**RE: 1836 COVE POINT ROAD
Annapolis MD, 21401
Variance Application**

VARIANCE PLAN
1836 COVE POINT ROAD
1836 COVE POINT ROAD, ANNAPOLIS, MD 21401
TAX ACCT. NO. 02-000-02456700
TAX MAP 045F GRID 0002 PARCEL 0540 DISTRICT 2ND
ANNE ARUNDEL COUNTY, MARYLAND

CONFIRMATION OF PRE-FILE

PRE-FILE #: 2025-0009-P
DATE: 02/06/2025
OPZ STAFF: Jennifer Lechner
Kelly Krinetz
I&P STAFF: Habtamu Zeleke

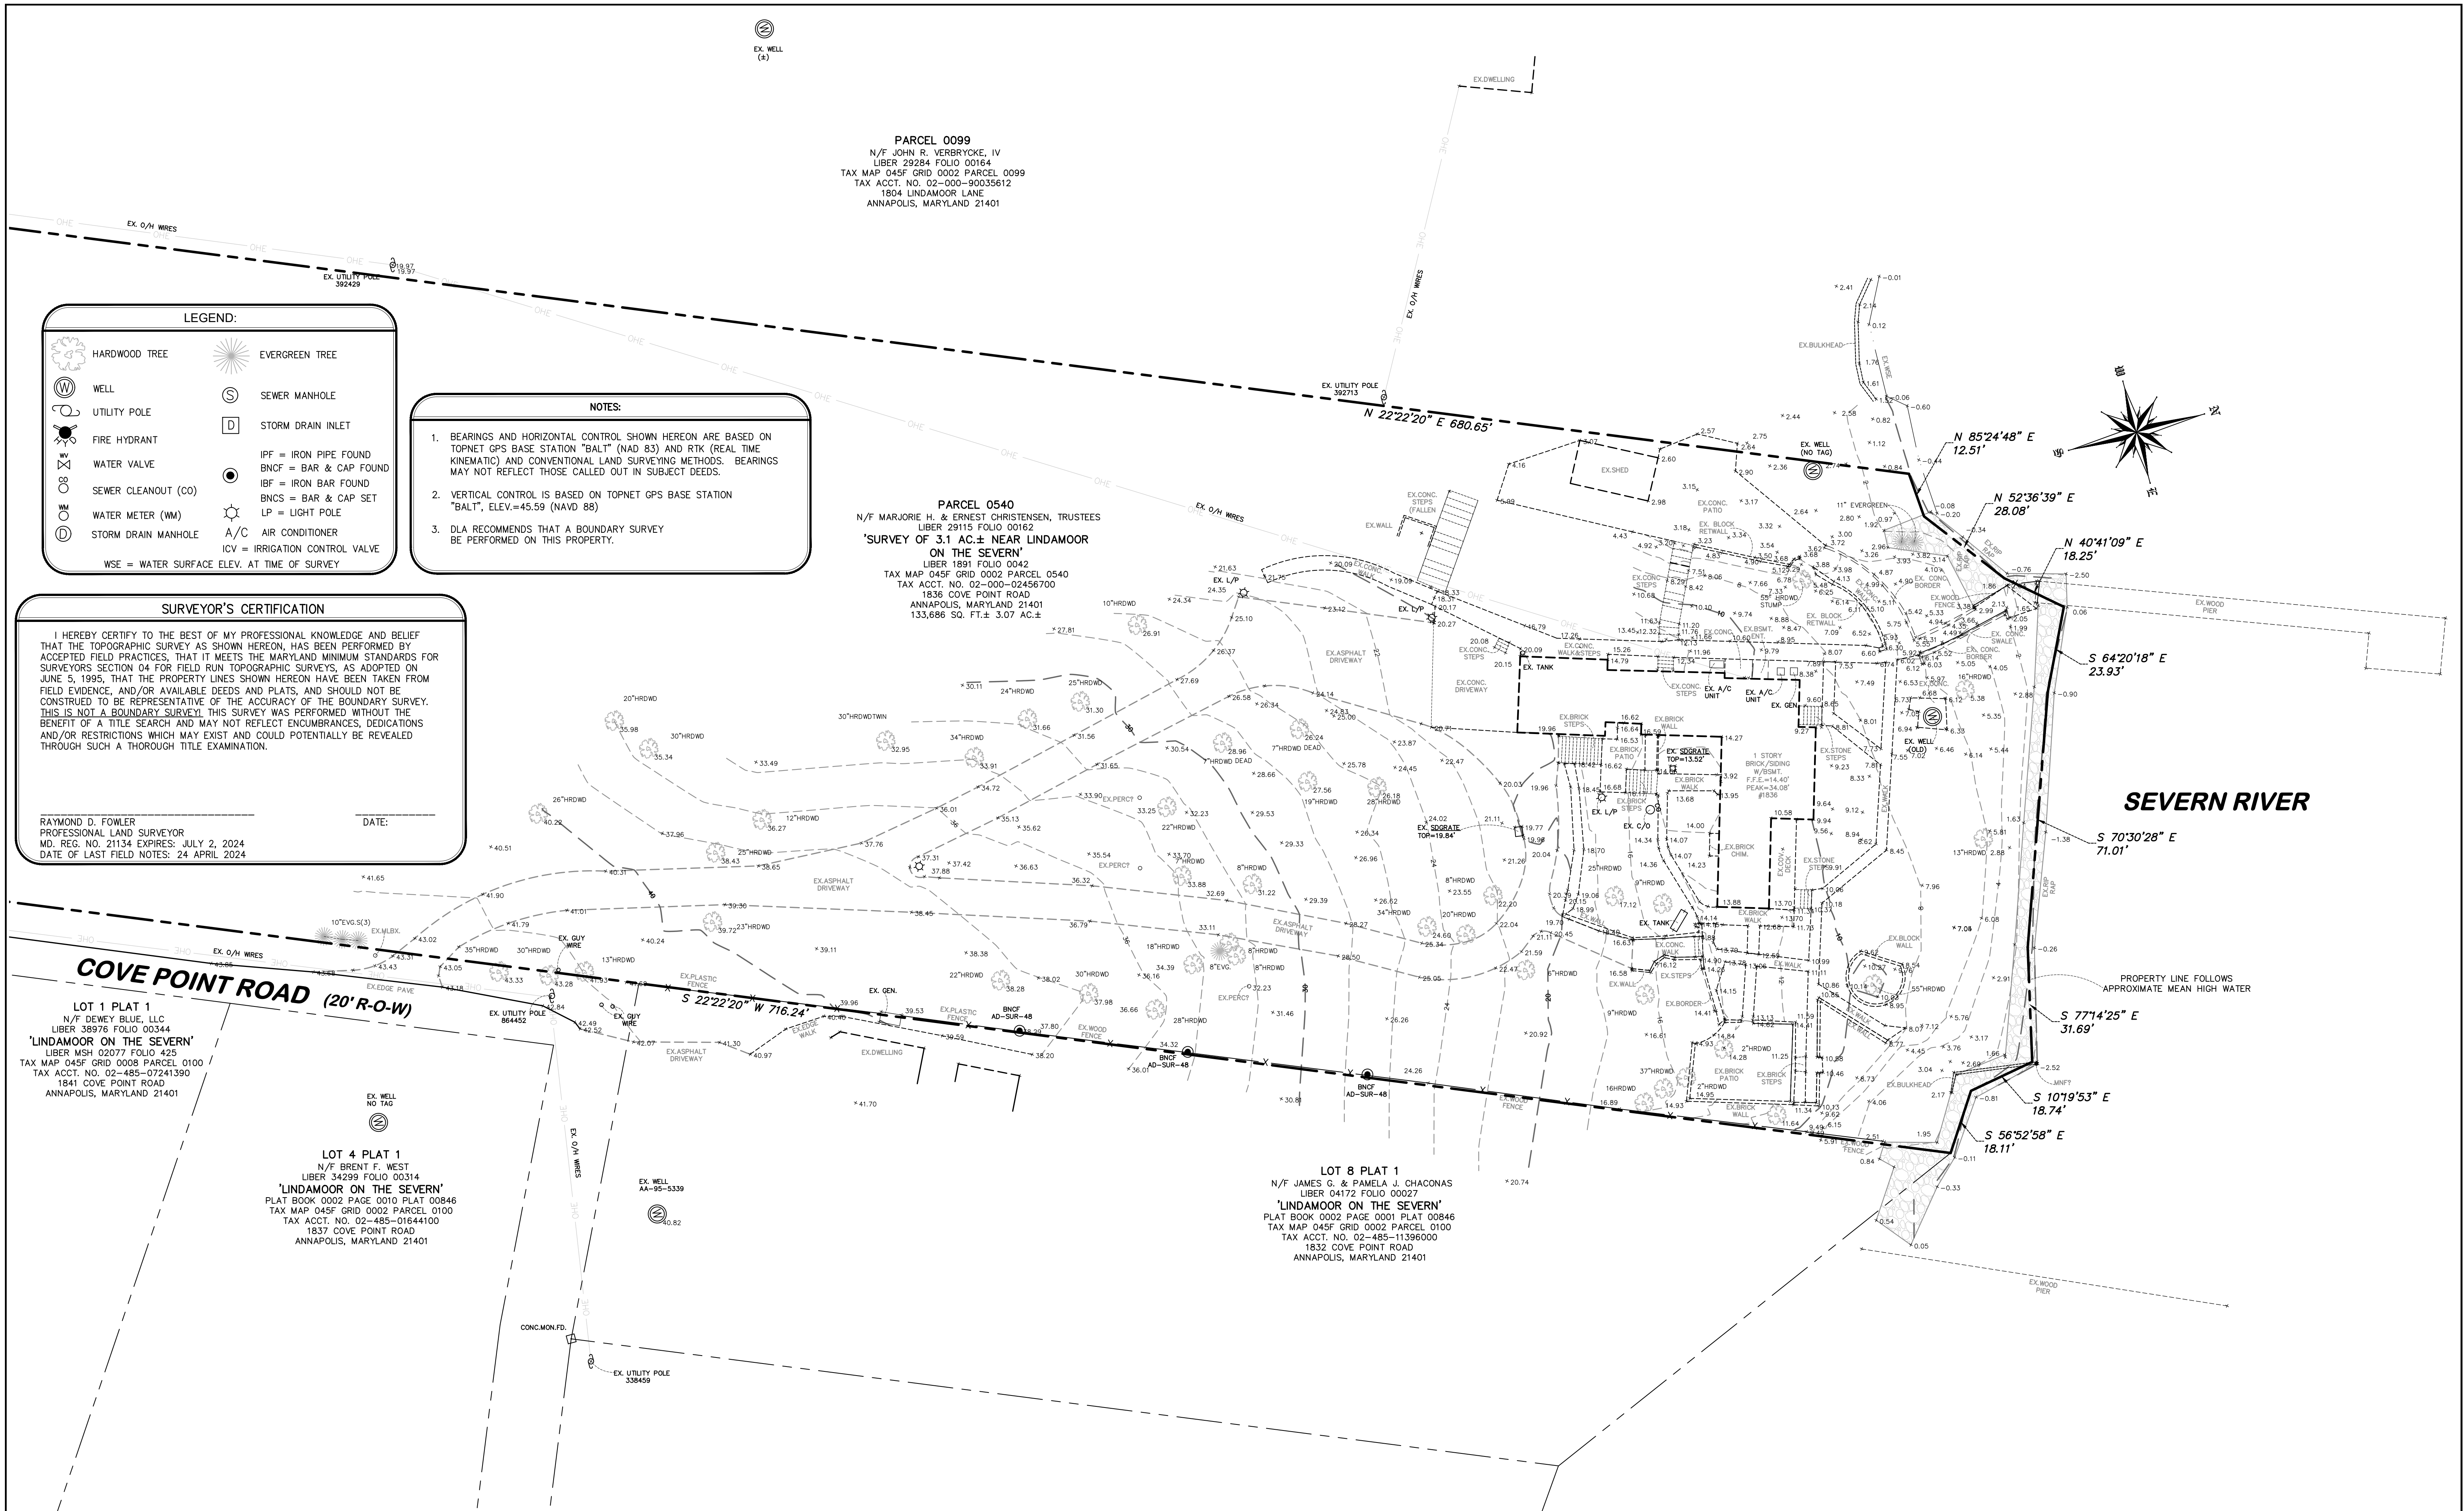
The site plan does not include the location of the proposed septic area. The driving force to the proposed location of the dwelling is the preservation of the existing woodland so the location of the septic area must be considered. Given the lot size, existing vegetation and the movement of the home back from the existing location, this Office has no objection to the generally in line request.

This Office has no objection to the location of the pool provided the applicant can demonstrate that there will be no additional slope disturbance related to the location. The proposed walkway expansion cannot be supported if it involves additional slope disturbance.

1. It is unclear how Stormwater management will be addressed for the raze and rebuild of the existing house.
2. Please ensure that the minimum well and septic setbacks to proposed SWM practices are achieved.
3. Per Code 17-6-404, disturbance within the 25' steep slope buffer (SSB) is prohibited.
4. All stormwater conveyance systems shall be designed so that no building or habitable structure, either proposed

or existing, is flooded or has water impounded against it during the 100-year storm event.

5. Per 6.1.4 (G) of the County Stormwater Practices and Procedures manual, SWM facilities shall not be located in areas that are off-limits to development, e.g., natural resource areas and their steep slopes and buffers.

6. Microscale stormwater facility(ies) design should incorporate safe conveyance for overflow discharges from 2, 10, 100-yr 24-hr storm events; plans should show overland relief paths for these storm events and ensure that no structures, or properties are negatively impacted or have water impounded against during these storm events.

7. Ensure the proposed improvement including runoff, seepage, and slope saturation does not adversely impact the integrity of the slope and potential impact of slope failure.

8. A soil boring is required per practice. The suitability and siting of proposed SWM practices should be reviewed. Soil boring information including verification of the suitability of in-situ soils for infiltration shall be submitted. Describe the site's hydrologic, and topographic characteristics and provide a recommendation on the feasibility of various BMPs.
